Product Improvement: P8264

September, 2001

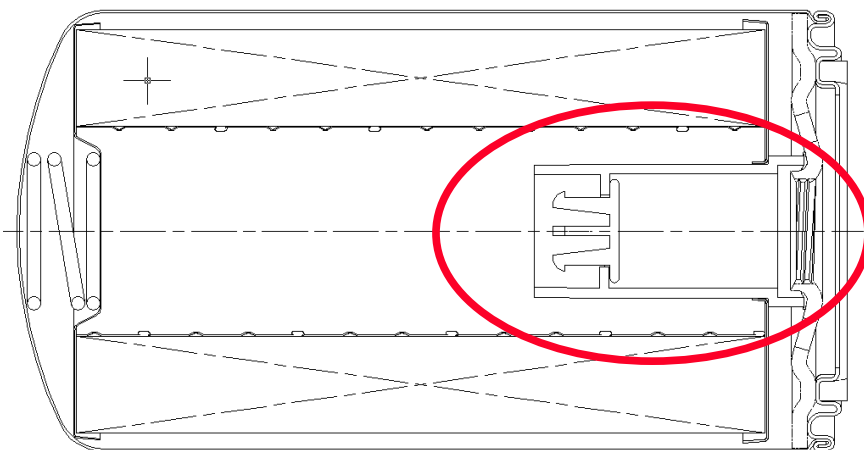
A “Stay-Clean” valve has been added to the **FRAM**® P8264 to insure compliance with the Caterpillar OE specification.

The Stay Clean Valve prevents dirty fuel from reaching the clean side of the filter. During service the valve is closed so that dirty fuel will not be filled into clean side of filter. The valve opens once fuel begins flowing through the filter media.

Visually, the Stay Clean Valve is all interior to the filter and appears as a black plastic disc recessed inside a black plastic tube. Below is a cut-away drawing of the filter with the valve and an actual image of the valve inside a filter.

The Stay Clean Valve was added to the P8264 in early March (date code 01060).
